**PLANNING COMMISSION AGENDA
APRIL 7, 2022 – 6:30 P.M.**

**CITY OF LA VISTA
PLANNING DIVISION
RECOMMENDATION REPORT**

NEBRASKA MULTI-SPORT COMPLEX
SITE & INFRASTRUCTURE PLANS

Figure 21. 2050 plus Event Capacity Analysis Summary

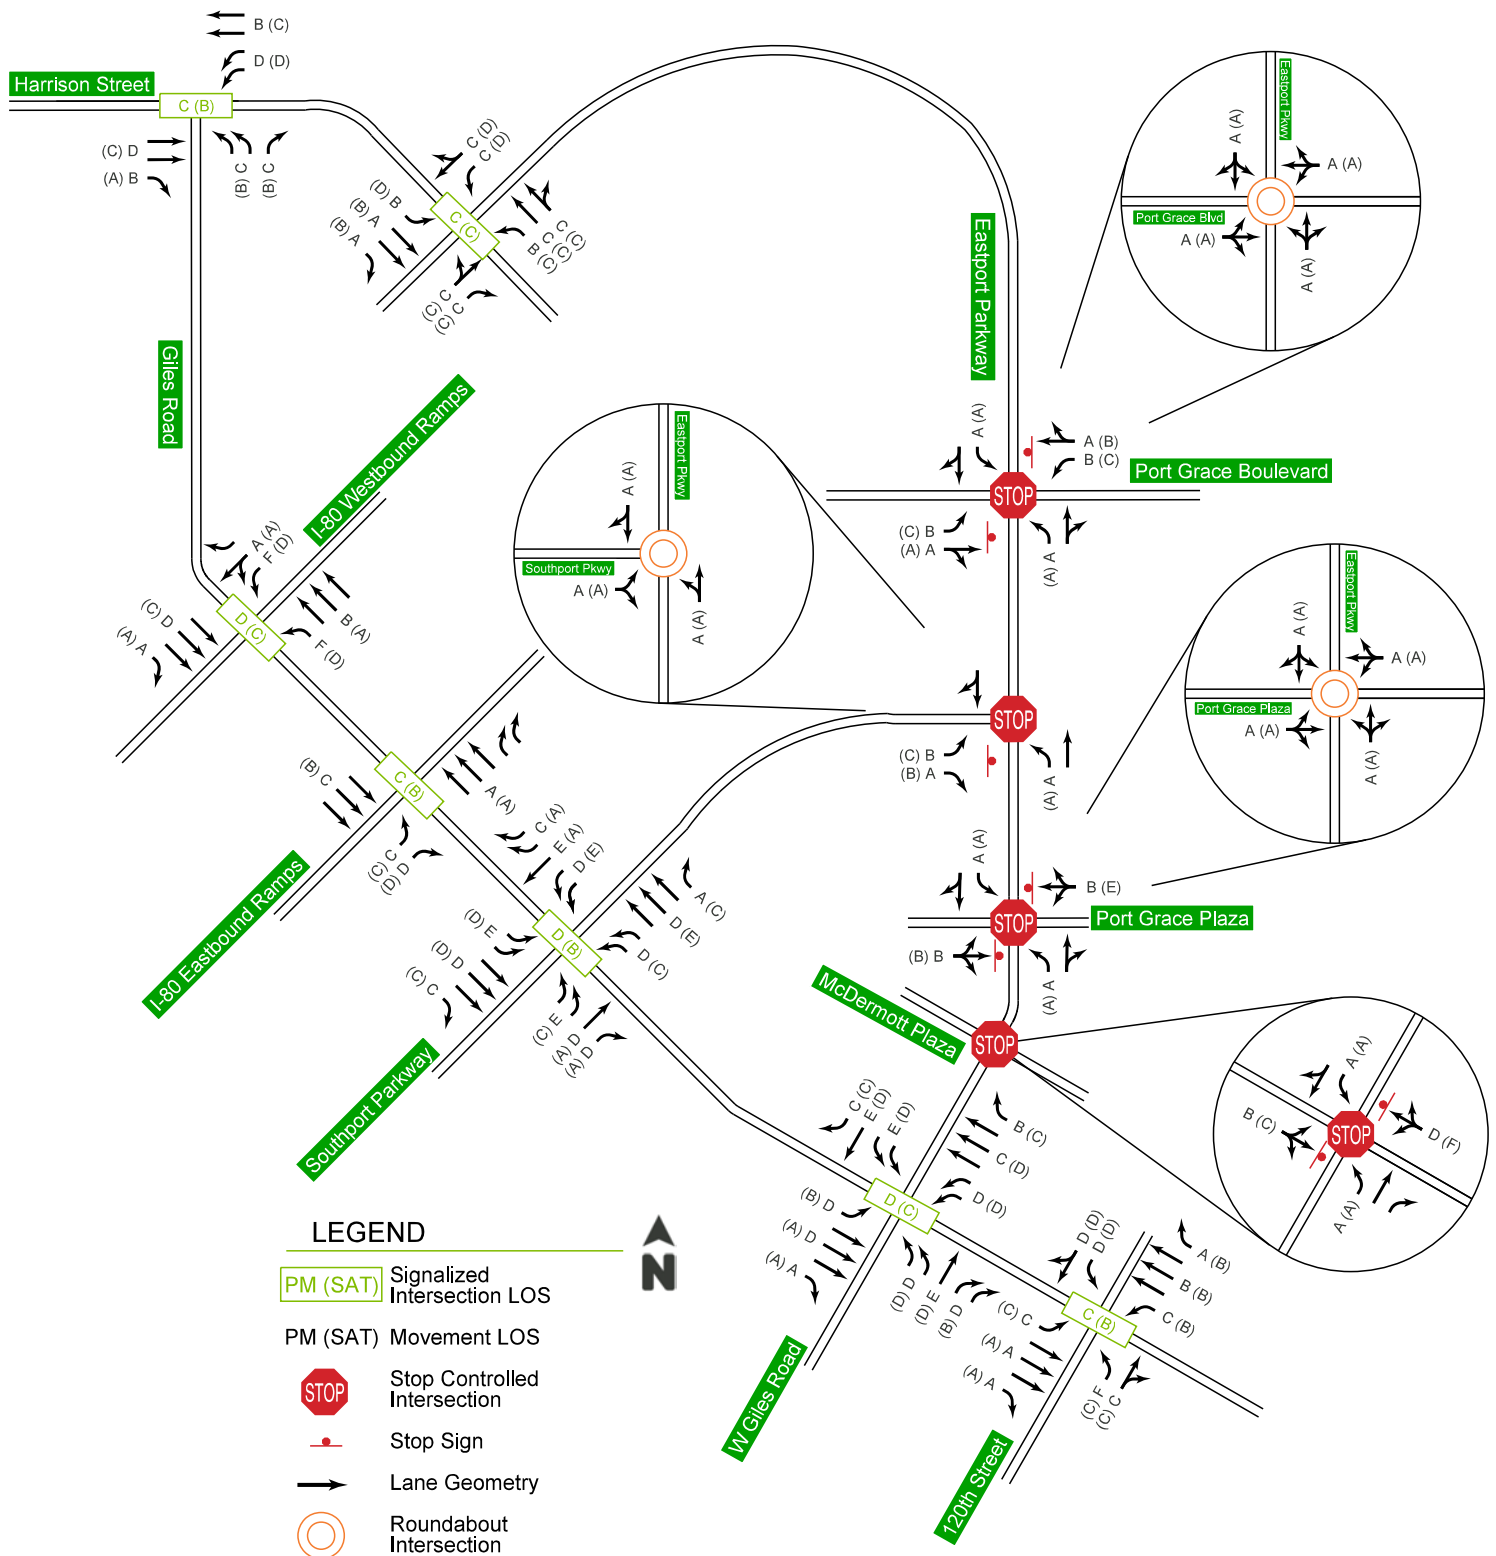
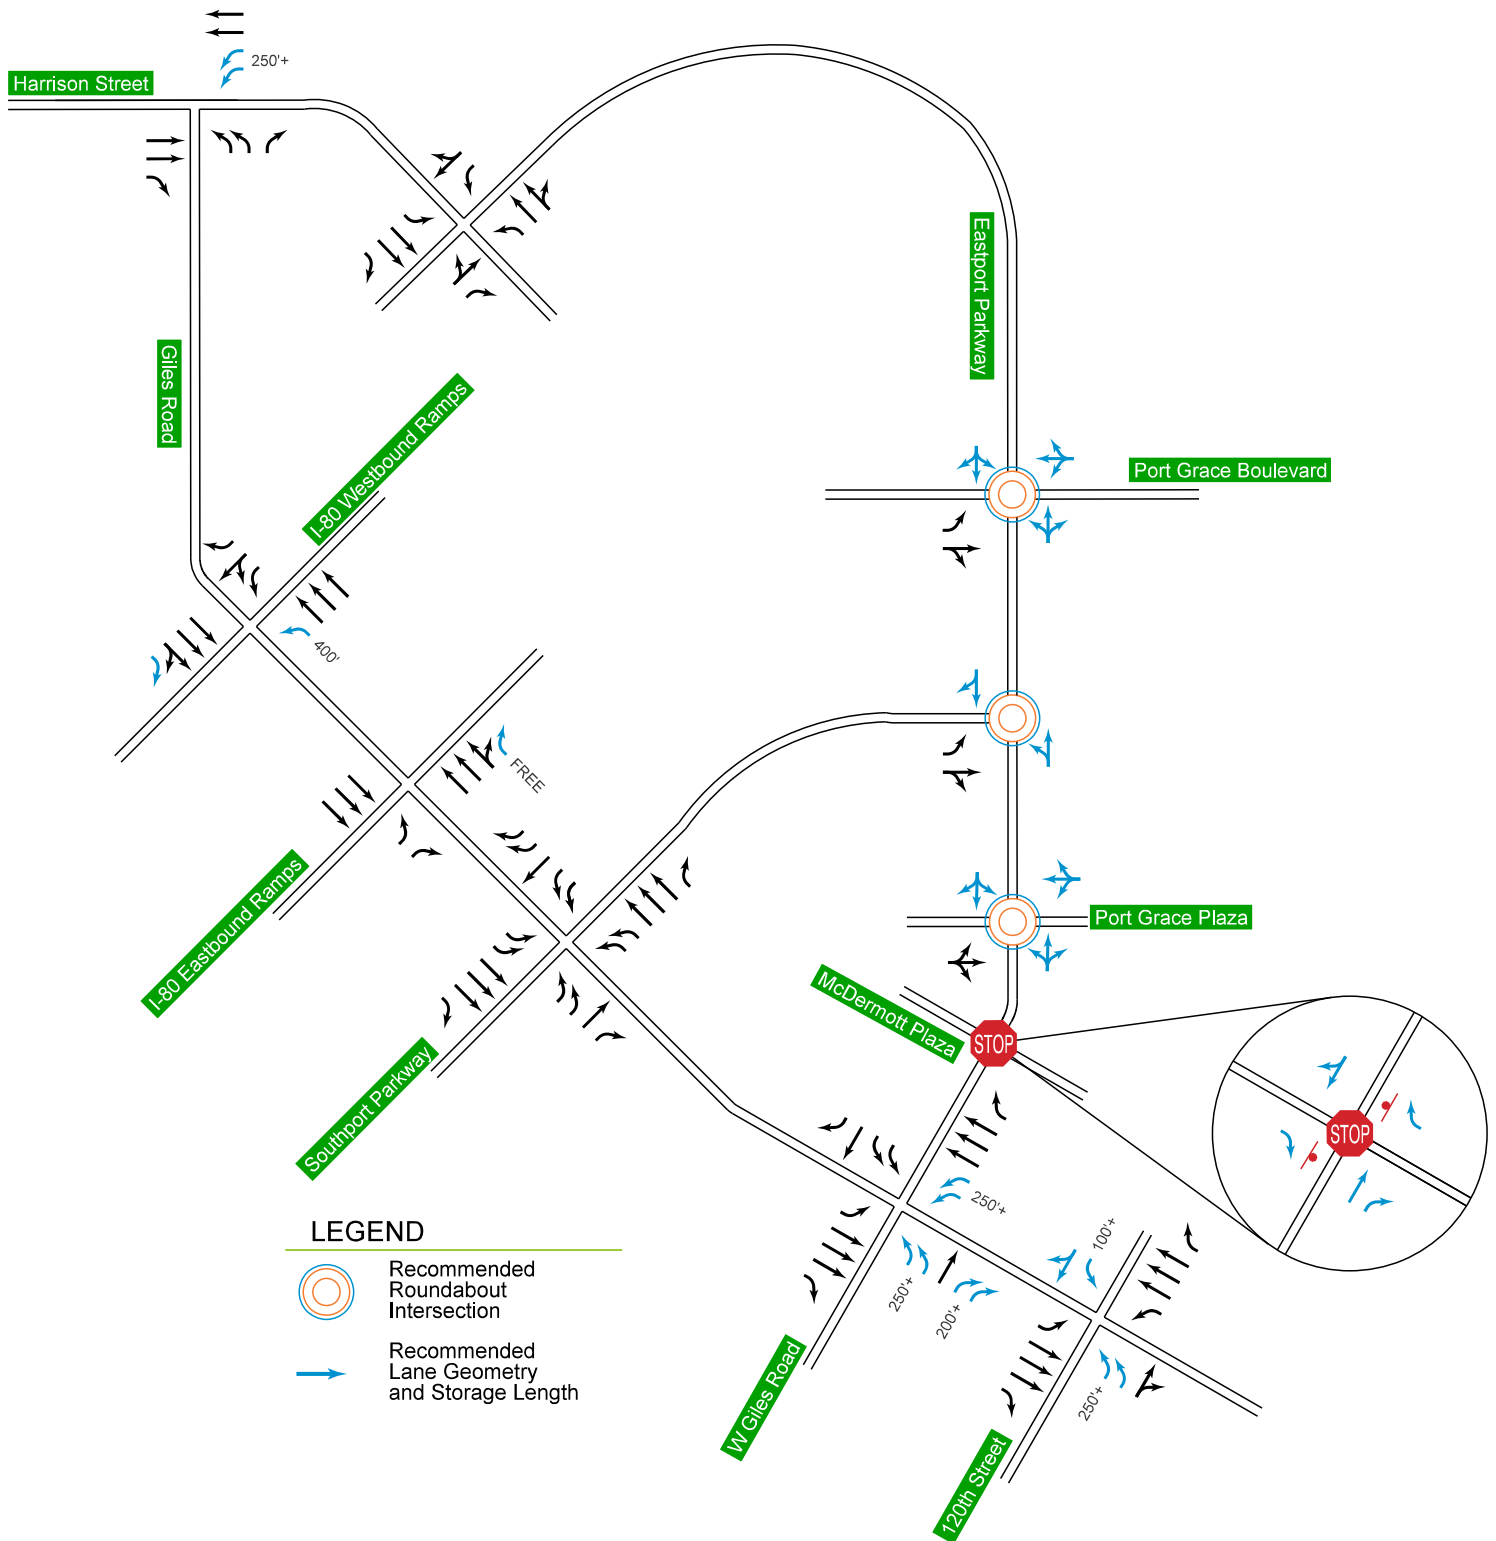
11. General: I-80 and Giles Road Interchange: Exclusive dual northbound right-turn lanes were recommended at the intersection of Giles Road with I-80 Eastbound Ramps, as shown on Page 39 / Figure 21. The recommendations shown on Page 44 / Figure 24 show the dual right-turn lanes as one shared through/right-turn lane with one exclusive right-turn lane. It should be noted that while this is a study recommendation, NDOT has not planned or supported the construction of dual northbound right-turn lanes at this location. Further coordination with NDOT will be required.
Please have the applicant clarify which lane configuration is recommended and update analysis and figures accordingly.
